CITY PLAN COMMISSION STAFF REPORT

Project Name
Master's Transportation HQ

CD-CPC-2023-00097
Development Plan - Non-Residential

L01

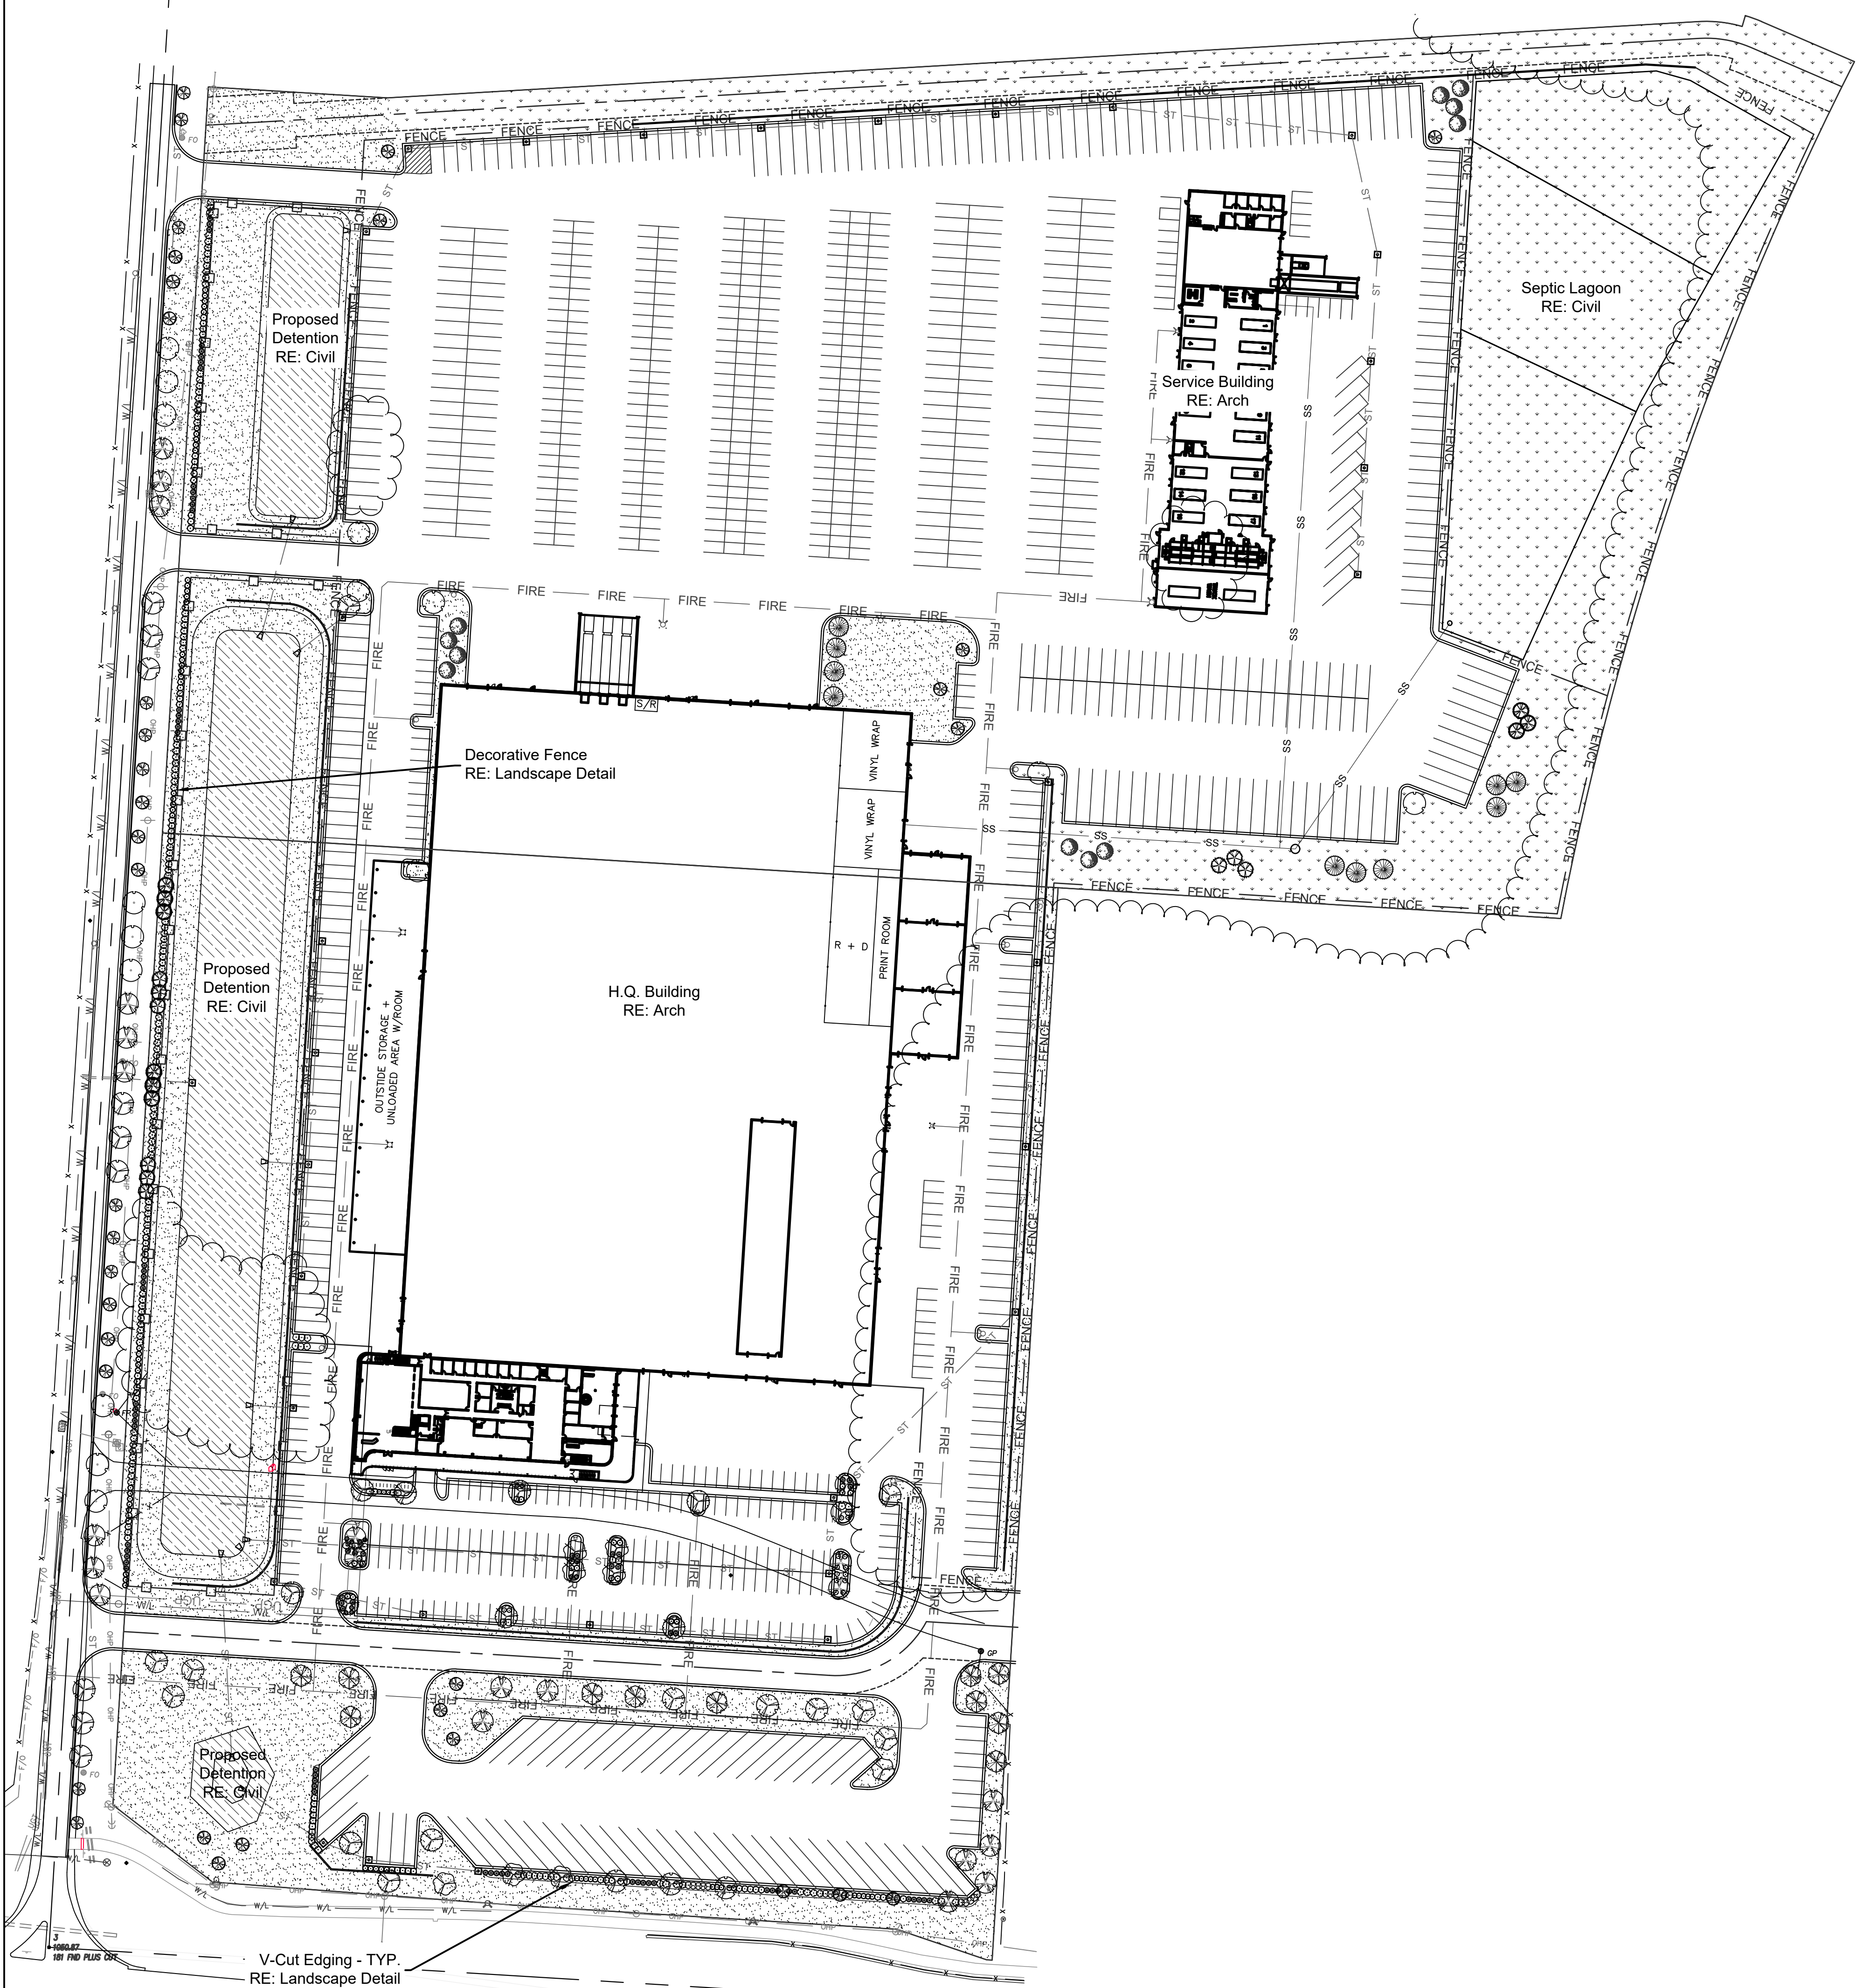
The proposed landscape plan proposes a large variety of tree and shrub species around the site. Some species include American Linden, Swamp White Oak, Colorado Spruce, Ninebark, Blue Spruce, and native seed mix for the detention basins. The entire development area will be fenced with a decorative iron rail fence, as staff requested, at various heights depending on the site location.

- G. Landscaping, berms, fences, and/or walls must be provided to buffer the site from undesirable views, noises, lighting, or other off-site negative influences and to buffer adjacent properties from negative influences that may be created by the plan.**
Proposed landscaping complies with the Code. Both street trees and 10 feet tall evergreen hedge will be planted on the west side of the site to screen the parking area and fenced outdoor storage area on

the side of the principle building. The plans show all detention basins will be planted with native seed mix.

1. The developer shall submit an affidavit, completed by a landscape architect licensed in the State of Missouri, verifying that street trees have been installed in accordance with the approved street tree planting plan and are healthy prior to Certificate of Occupancy.

2. The developer shall submit an affidavit, completed by a landscape architect licensed in the State of Missouri, verifying that all landscaping required of the approved plan has been installed in accordance with the plan and is healthy prior to Certificate of Occupancy.
